DEVELOPMENT REVIEW COMMITTEE (DRC) COMMENT REPORT

PROJECT NAME: SE 21st Street Residences

CASE NUMBER: UDP-S23012

REQUEST: Site Plan Level III Review: Conditional Use for Mixed-Use Development With 17 Multifamily Residential Units and 2 Live Work Units

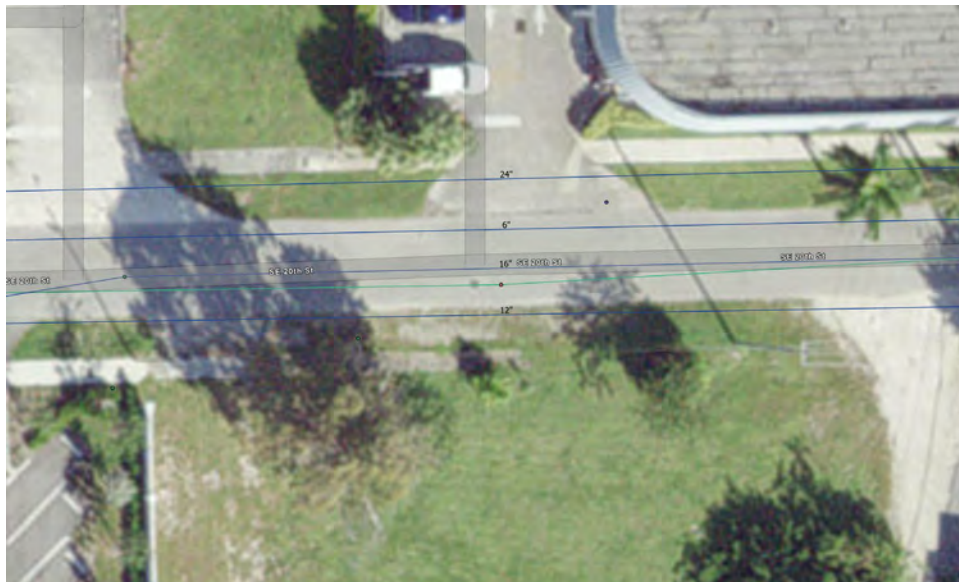
8. Dumpster enclosure doors need to be coordinated between Site plan and Civil drawings. Doors shall not open onto public right-of-way.
9. The following wood poles should be relocated.
 - a. Existing wood pole on 16 ft public alley near the proposed dumpster enclosure conflicting with pavement.
 - b. Existing pole and anchors on SE 20 St conflicting with sidewalk.
 - c. Existing wood pole and anchor conflicting with alley access on SE 20 St.
10. Water and Sewer Plans
 - a. On the North Water plan, do not place the proposed clean out in the proposed Detectable warning surface.
 - b. The existing utilities do not appear to be depicted correctly. See image from GIS below:
